DESCRIPTIVE REPORT

Type of Survey Hydrographic
Field No. RA-10-16-97
Registry No. H-10761

State Alaska
General Locality Southwest Alaska Peninsula
Sublocality Katmai Reef and Vicinity

EVALUATION REPORT

ATTACHMENT A
H10761 LIMITS DELETED ON CHART 18686
8th EDITION, AUGUST 3, 1998.
LIMIT LINE DENOTES AREA OF SUPERSESSION
LIMIT LINE DENOTES AREA OF SUPERSESSION

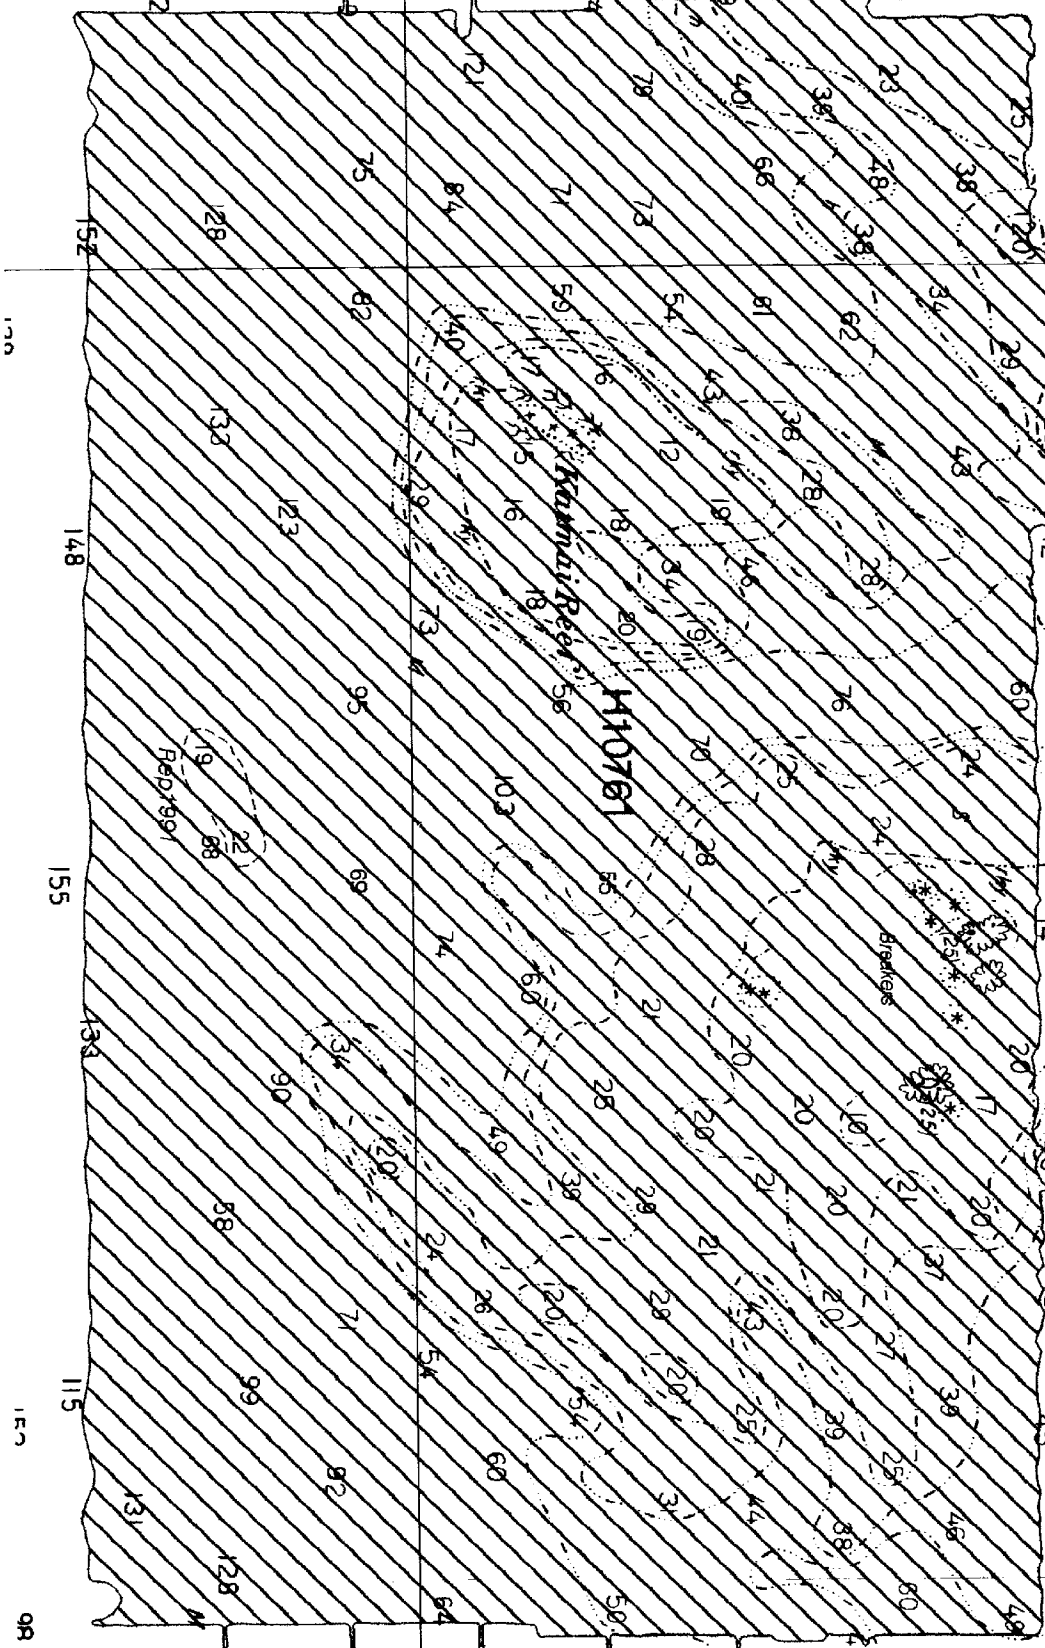
The hydrographer has determined the survey limits in accordance with the approved sheet layout and project limits created in MapInfo. A page size chartlet of the survey area indicating the limits of supersession is included in this report as Attachment A.
